ADC Telecommunications		A0	20028104	5/17/99	LRT		
		REV	ECO	DATE	APV		
APV	THIS PRINT IS THE PROPERTY OF ADC, IT SHALL NOT BE COPIED WITHOUT PERMISSION.		TITLE SCH, SINGLE STAGE AMPLIFIER ASSY, CLASS A, HIGH BAND (1265-1417)				
DATE							
ECO	MATERIAL -----	DWN	GK	1/29/96	DWG. NO.		REV
REV	FINISH -----	CHK	JAG	3/19/96	1265-3417		A0
		REL	JAG	3/19/96	C	SCALE ---	SHEET 1 OF 1

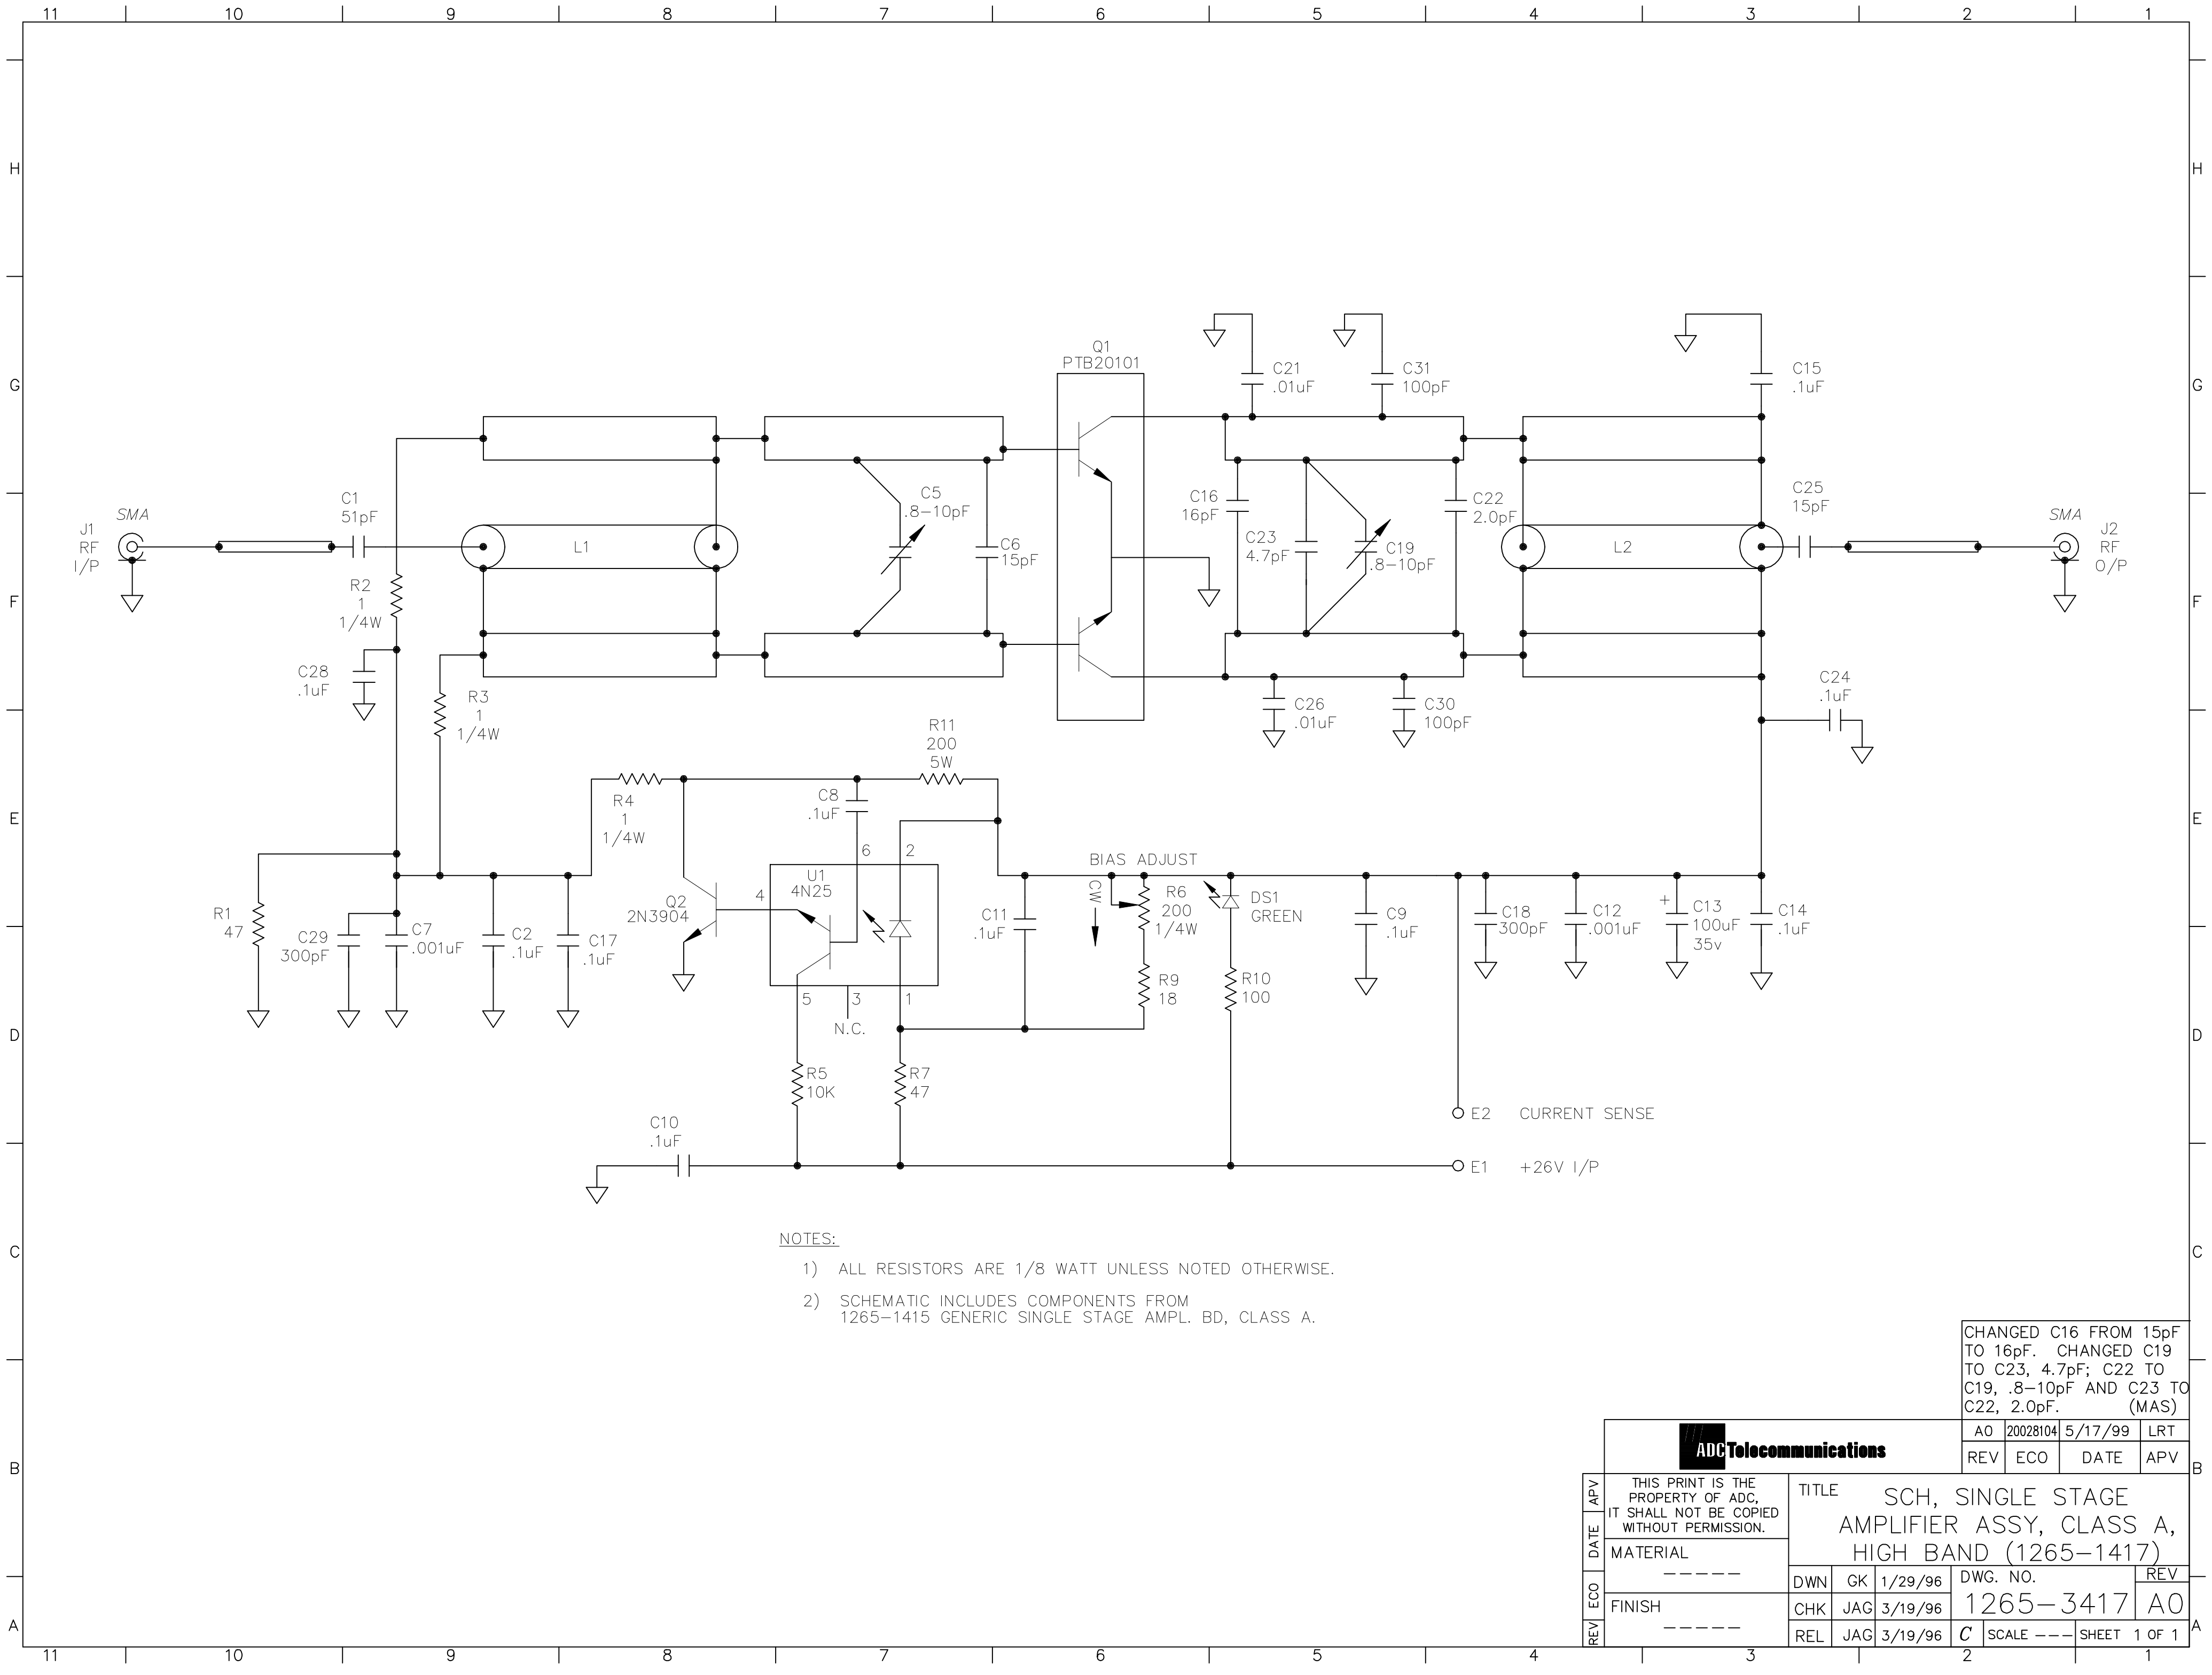
CHANGED C16 FROM 15pF TO 16pF. CHANGED C19 TO C23, 4.7pF; C22 TO C19, .8-10pF AND C23 TO C22, 2.0pF. (MAS)
